Introduction

The Urban Design team has conducted a review of Planning Proposal 30-46 Auburn Road, Regents Park with the aim of addressing the questions listed below:

Scope of the review

Figure 1 - Massing of proponent's scheme

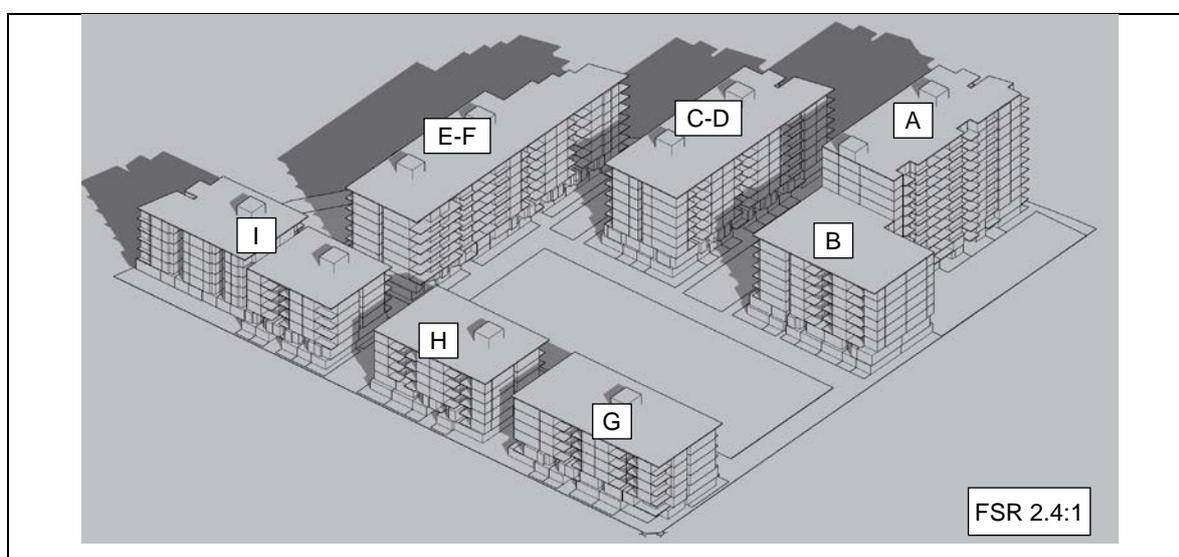
- The Urban Design Branch conducted a massing test to synthesis some of the outcomes from the reviews described in Parts IA and IB of this document. A test was conducted using the Amended Architectural Plans submitted to the Department prepared by Studio MRA.
- The massing test (see **Figure 1**) further confirmed that towers **A-B**, **C-D** and **E-F** fail to comply with adequate solar access requirements. This is limited due to cumulative impacts of:
 - a) a great portion of south-facing units not receiving direct sunlight;
 - b) the proposed layout of buildings which results in internal overshadowing of units, and
 - c) the bulk and height of buildings resulting from the target FSR of 2.4:1

Figure 2 - Council's proposed setbacks on proponent's scheme

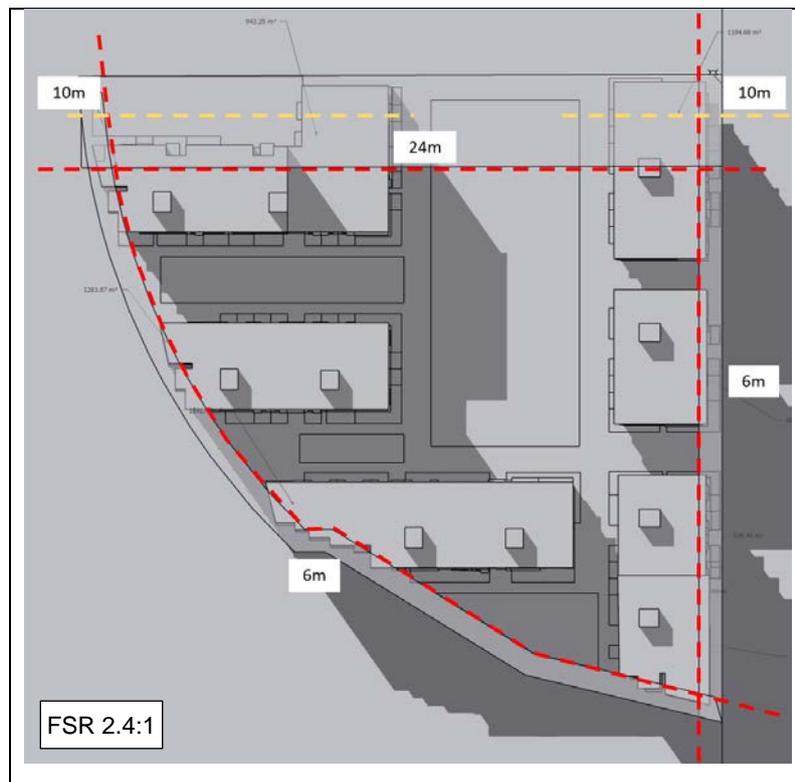
- The final line of investigation conducted by the Urban Design Branch, responded to Canterbury-Bankstown Council response to Gateway Review request: *“the setbacks demonstrated in the latest proponent design are inconsistent with those proposed by Council and will likely create poor interfaces with Auburn Road, the railway corridor and neighbouring industrial land.”*
- The Urban Design Branch Integrated Council’s proposed setbacks into the proponent’s scheme to test the impacts upon the current layout.
- The exercise confirmed that the proponent’s scheme is not compliant with none of Council’s proposed setbacks and showed a significant portion of GFA is currently located outside these boundaries. (refer to **Figure 2**)

- The Urban Design Branch conducted an additional opinion being **Alternative Design 3** which:
 - a) Assessed council’s proposed setbacks and contained the built form within these boundaries,
 - b) built upon Alternative Design 2 for improved solar access,
 - c) allowed tower separation of 18m to respond to ADG requirements for buildings up to 8 storeys,
 - d) retained the proposed central green open space and its perimeter road.

- The purpose of this test was to explore a likely FSR of a development scheme which: retains adequate solar access, retains amenity provisions such as and central green open space; and enables the setback controls proposed by Canterbury-Bankstown Council and utilises the proponents building typologies.
- The outcome of Alternative Design 3 delivered an FSR of 1.9:1
